CITY OF AUSTIN
Board of Adjustment
Decision Sheet
E-1

CASE NUMBER: C15-2020-0083

ADDRESS: 2810 GONZALES ST

Master Comment Report

The Salazar Residence
2810 Gonzales St.
Austin, Texas 78702
SITE PLAN

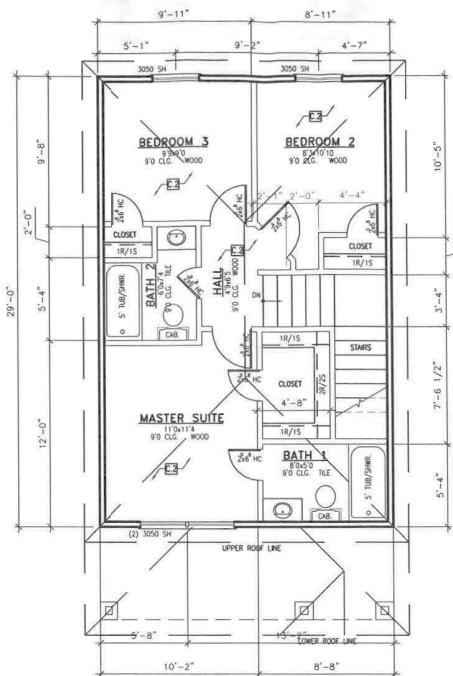
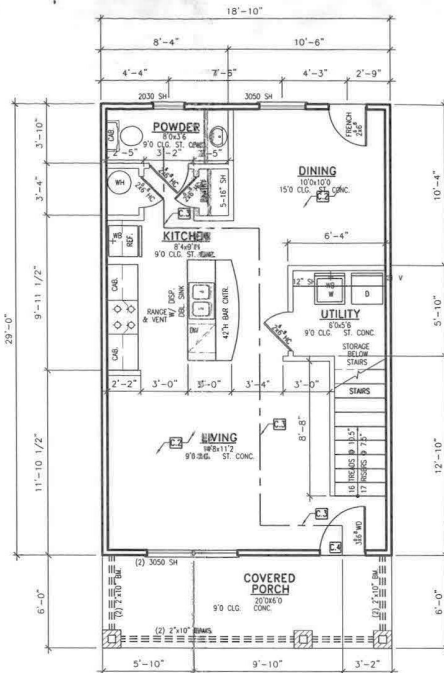
2. The existing storage shed above, is described on the site plan as a garage. As this structure is not permitted as a garage, please remove note.
3. SUBCHAPTER F: Part of the architectural plans are missing architect's signature. This lot is located in the Subchapter F overlay boundaries and is more than one story or is greater than 20 feet. The plan set must be signed and sealed by Texas Licensed Architect or Certified Building Design Profession. Please refer to documentation requirements on the application – Design Professionals.
